**Subject: Maverik Gas and Convenience Store Traffic Impact Study  
Southwest quadrant of I-25 and Jefferson Street  
Albuquerque, Bernalillo County, New Mexico**

This letter is to inform you that the **FINAL** Traffic Impact Study (TIS) for the proposed Maverik Store on the southwest quadrant of I-25 northbound off-ramp and Jefferson Street Interchange dated March 18, 2019 has been reviewed.

## EXHIBIT A

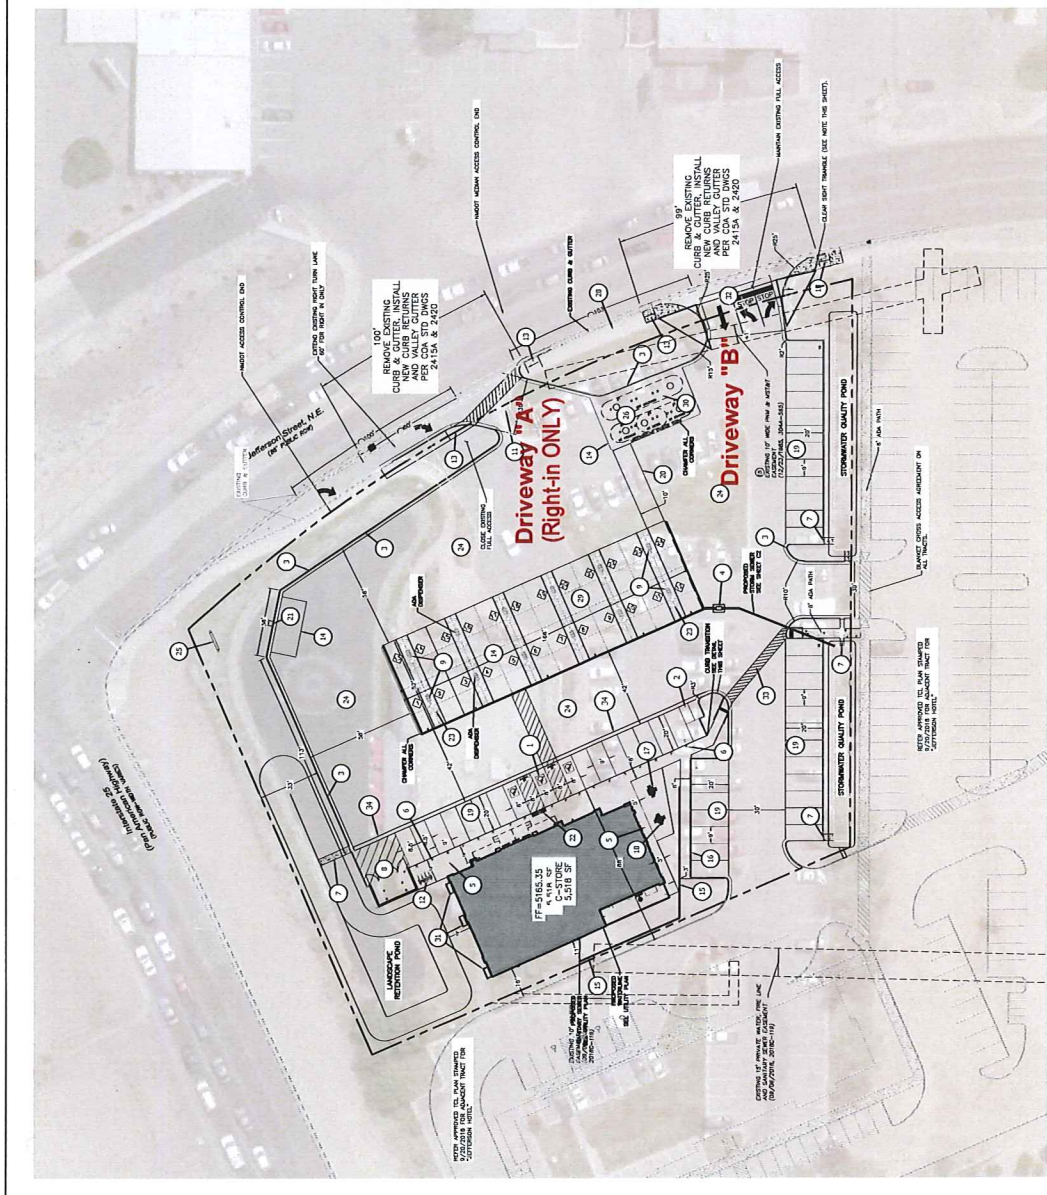
The NMDOT has no objection to the partial access at Driveway "A" on Jefferson Street located 275-feet southeast of the signalized intersection of I-25 northbound off-ramp and Jefferson Street. The proposed Maverik Store site plan is shown in Exhibit A. NMDOT gives final concurrence of this development given the conditions below are met. This TIS proposed the recommendations shown in Exhibit B.

3. Driveway "A" shall be built as a RIGHT-IN ONLY driveway with enhanced median islands to prevent a potential left/right-out from occurring.
4. The development shall construct a deceleration lane at Driveway "A" that is 200 feet in total length (including taper).

5. Driveway "B" does not meet the State Access Management Manual's corner clearance spacing for a full access.
6. The development shall provide a platted access easement to the property to the south to prevent an additional access request along Jefferson Street.
